Site Name: EAST PECOS FEDERAL 22 #009H	Site Type: Oil Production Site
Date Release Discovered: January 4 th , 2022	API# (if applicable) 30-015-43349

**Re: Remediation Work Plan Addendum
East Pecos Federal 22 #009H
Incident Numbers NVV2003433576, NRM1935238930, NRM2001038937 and
nAPP2200730406
Eddy County, New Mexico**

Ensolum, LLC (Ensolum), on behalf of WPX Permian Energy, LLC (WPX), has prepared this Remediation Work Plan Addendum (RWPA) to address deficiencies in the January 21, 2021 and April 4, 2022 Remediation Work Plan (RWP) identified by the New Mexico Oil Conservation Division (NMOCD) and to recommit to remedial actions for the East Pecos Federal 22 #009H (hereinafter referred to as the "Site") located in Unit M, Section 22, Township 26 South, Range 29 East, in Eddy County, New Mexico (**Figure 1 in Appendix A**).

Figure 2 – Soil Sample Locations

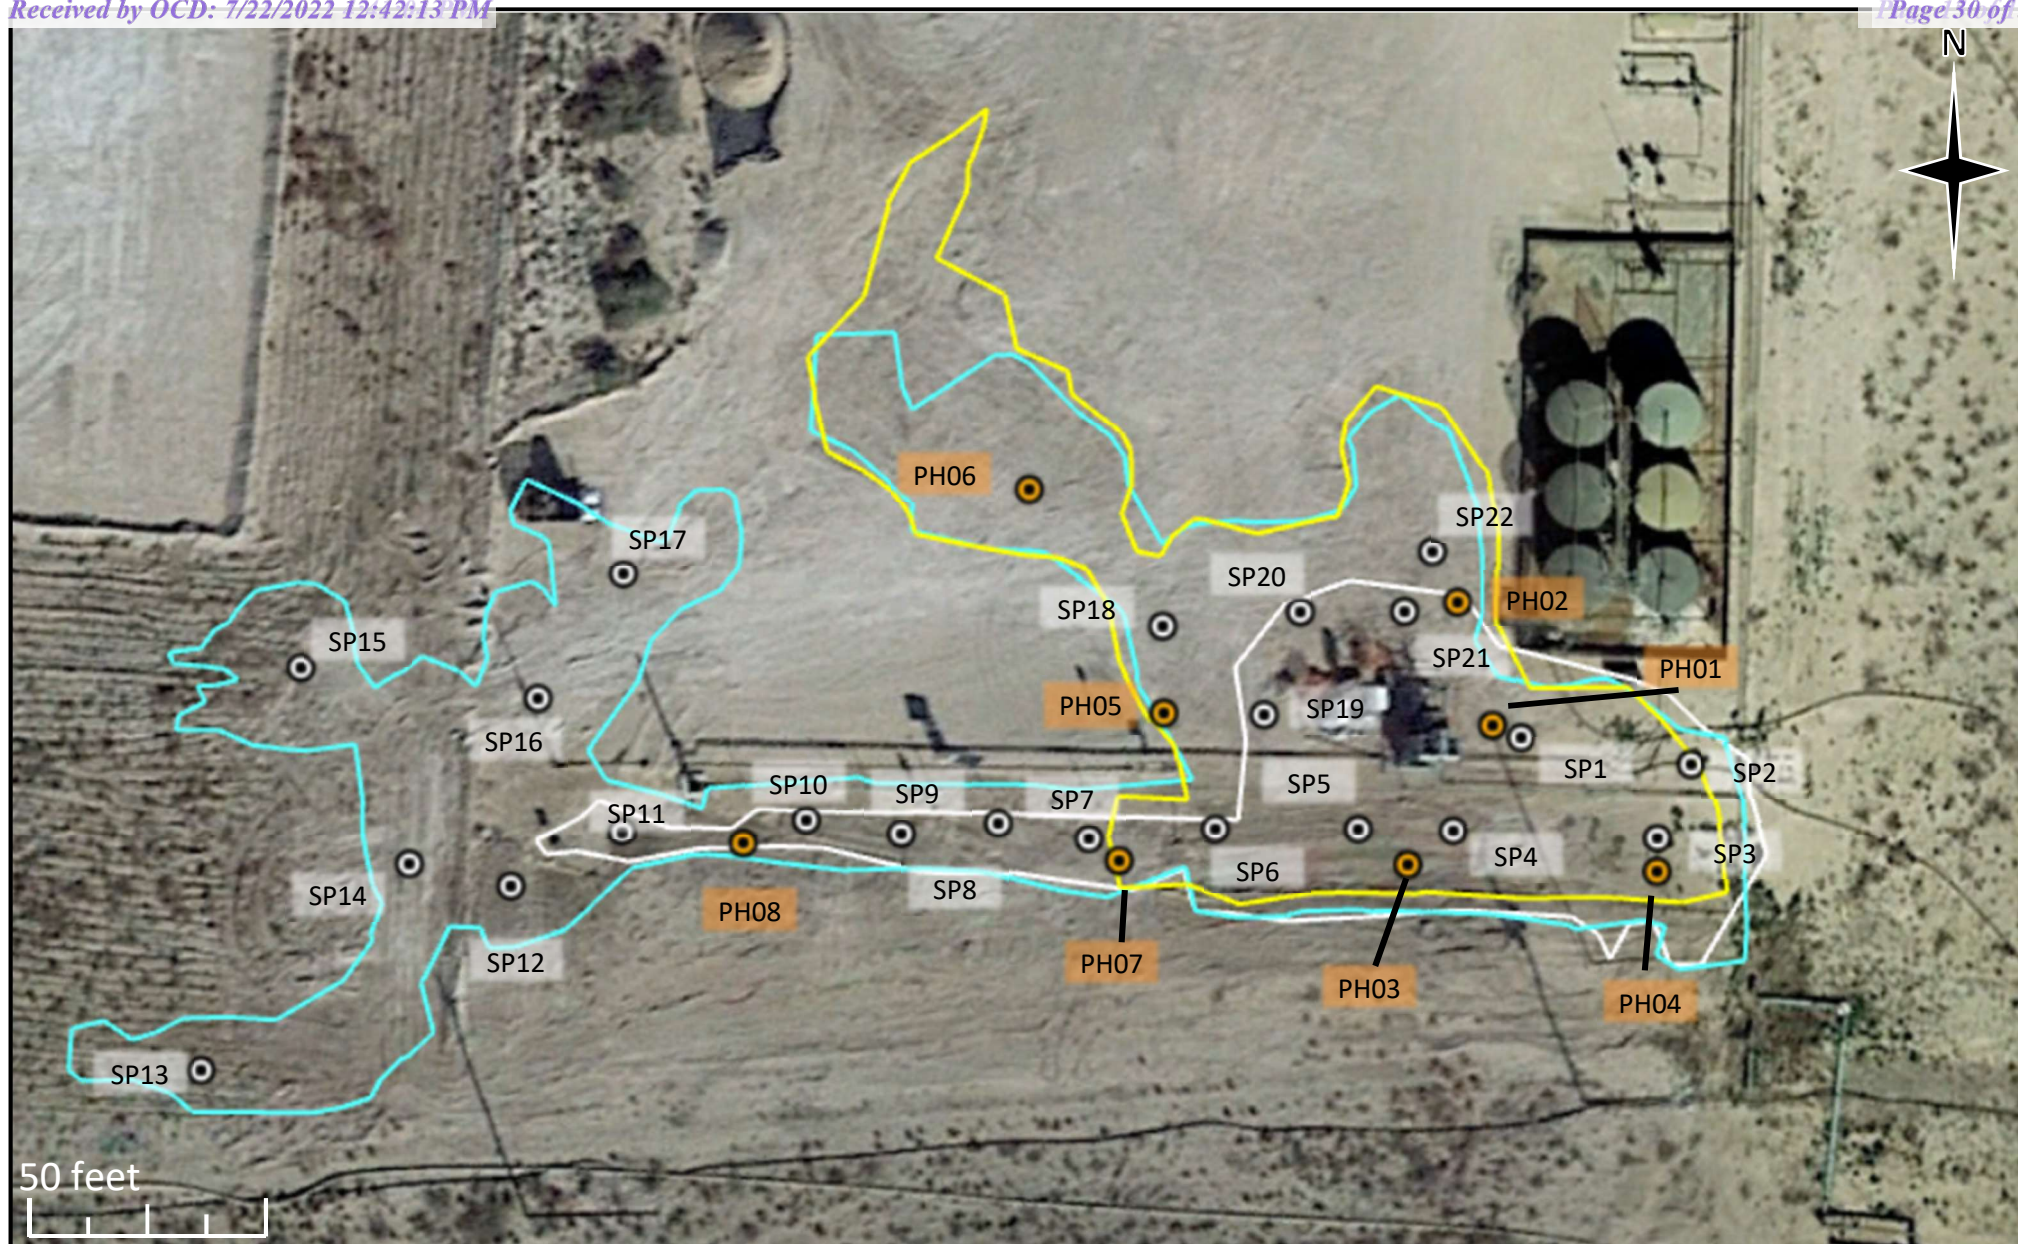
Remediation Plan Denied. Please complete boring advancement and groundwater determination prior to Remediation Plan submittal. Please determine and present final method of remediation in plan. Please resubmit revised Remediation Plan by May 20, 2022.

- Based on laboratory analytical results associated with delineation soil samples PH03 and PH04 and surface soil samples SS02 and SS04, concentrations of contaminants of concern (COCs) greater than the NMOCD Closure Criteria will be excavated and sampled in accordance with the Closure Criteria and/or Reclamation Standard (**See Figure 2 in Appendix A**);

As a result of the denials, a soil boring was installed north of the releases and on location (32.021479, -103.975048) to assess depth to water beneath the Site (**Figure 2 in Appendix A**). WPX contracted Atkins Engineering Associates (Atkins) out of Roswell, New Mexico, to advance a soil boring TW-1 (New Mexico Office of State Engineer (NMOSE) File # C-4630) via solid stem auger to a total depth of 55 feet bgs. Atkins completed the soil boring TW-1 on June 15, 2022. During drilling activities, the lithology and observed soil conditions for evidence of a water-bearing zone were documented by Atkins. Soil boring TW-1 was drilled to 55 feet bgs and was allowed to stabilize for at least 72 hours. The NMOSE Well Record & Log for soil boring TW-1 included in **Appendix C**.

Figure 4
East Pecos Federal Com 22 #001H/009H
Permian Basin, Eddy County, NM

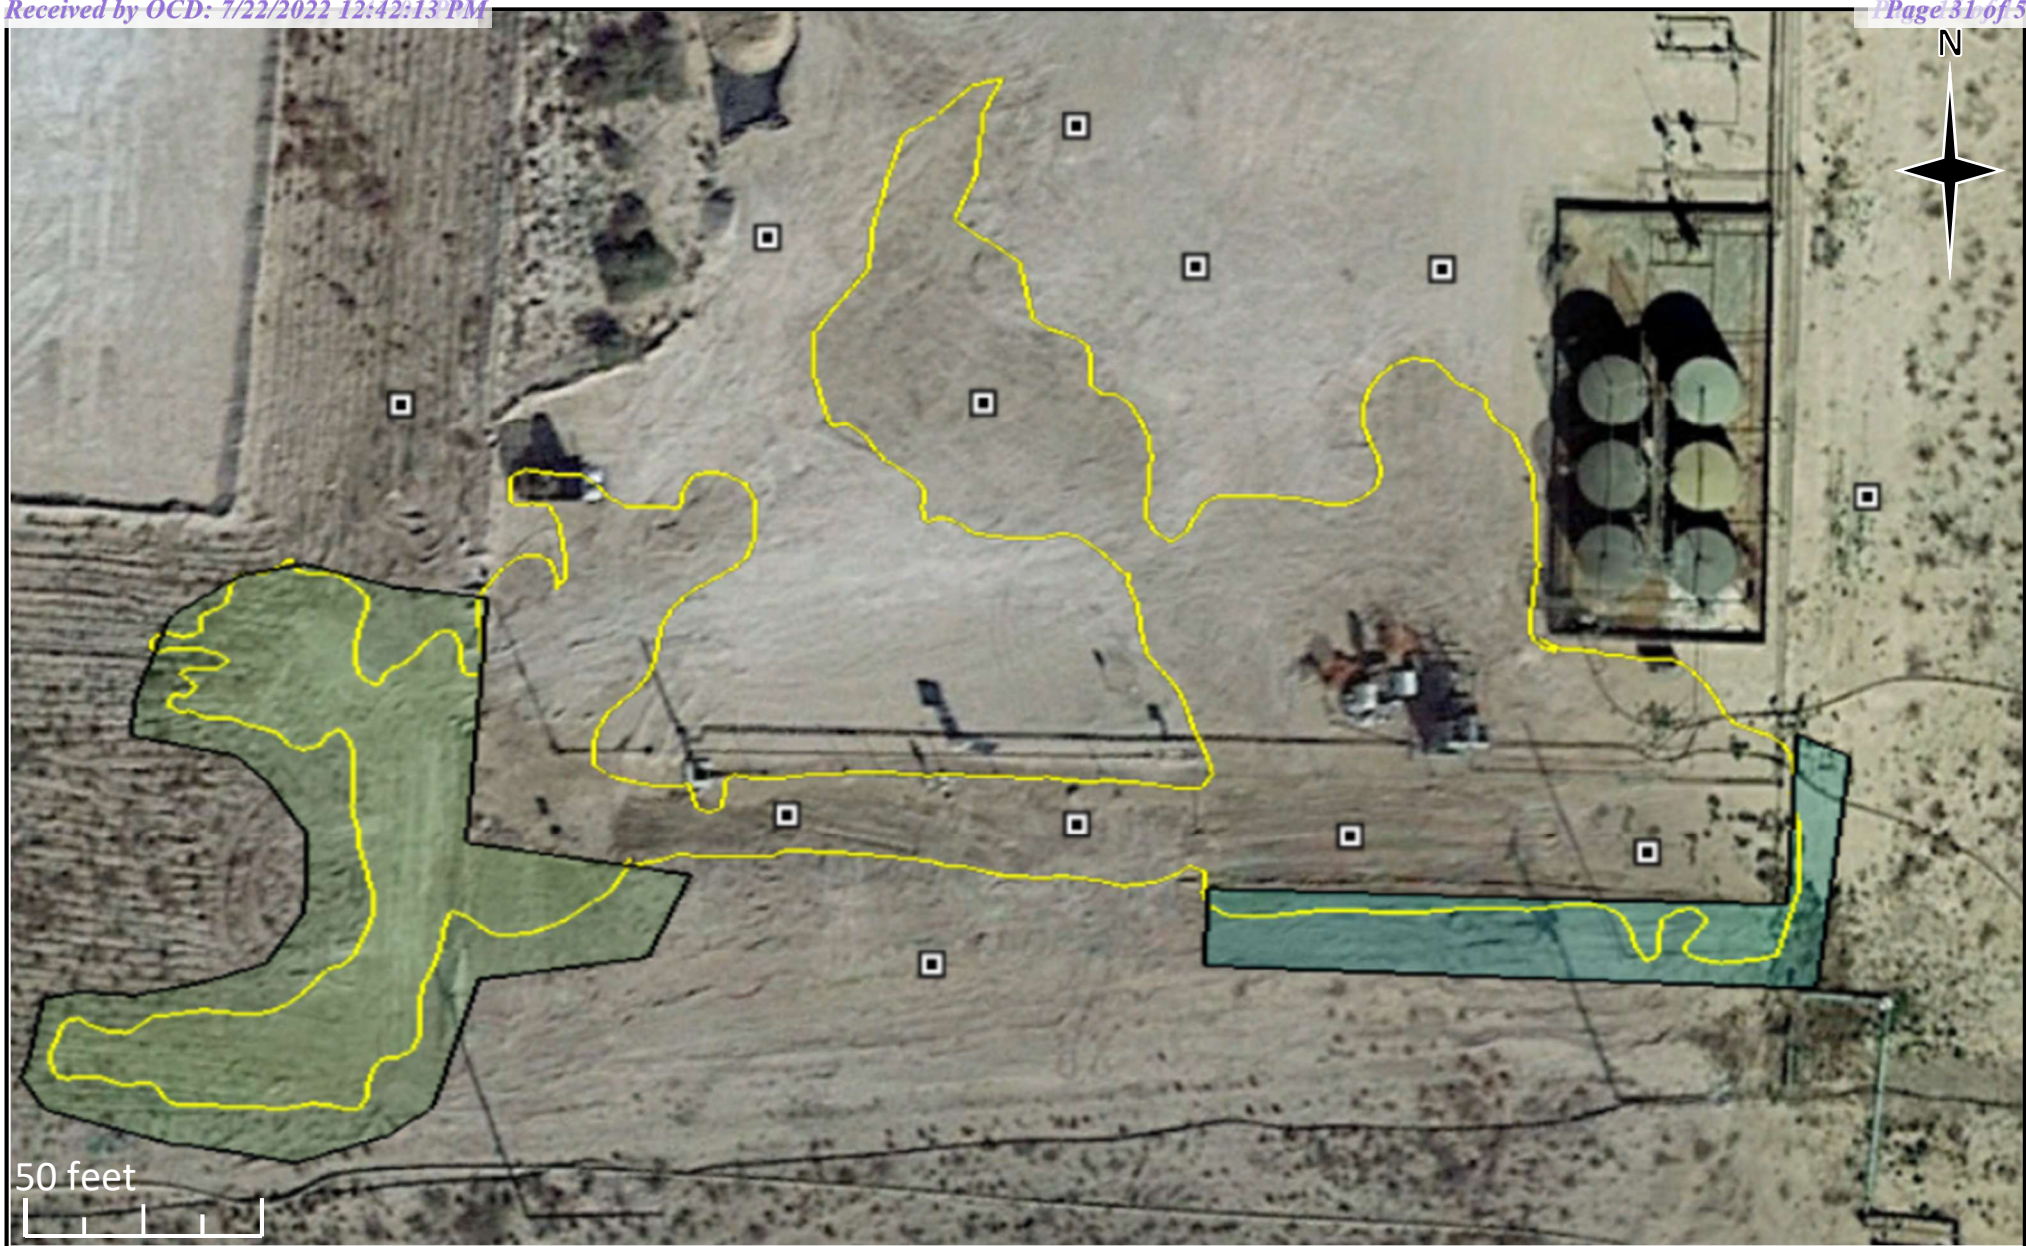
- Based on laboratory analytical results associated with delineation soil samples on pad (PH01) and off pad (SP12 through SP15), COCs are greater than the applicable NMOCD Closure Criteria and/or Reclamation Standard and will require remediation. Additionally, an off-pad area to the southeast will be addressed as proposed in the original RWP (**See Figure 3 and 4 in Appendix A**);
- Based on current delineation soil laboratory analytical results and extent of the release areas, an estimated **1,550 cubic yards** of impacted soil are anticipated to be remediated and/or removed from the Site for disposal in accordance with state and federal regulations;
- Based on laboratory analytical results for delineation soil samples on pad (excluding PH01) no remediation efforts are required in these areas.

Created By	Condition	Condition Date
jnobui	Remediation Plan Approved with Conditions. Remediation Plan Approved to excavate soils and transport excavated soils to a New Mexico approved landfill. Any alternate remedial method (ex. onsite ex-situ treatment) will require submission of a separate Remediation Plan specifying approved protocols.	8/9/2022
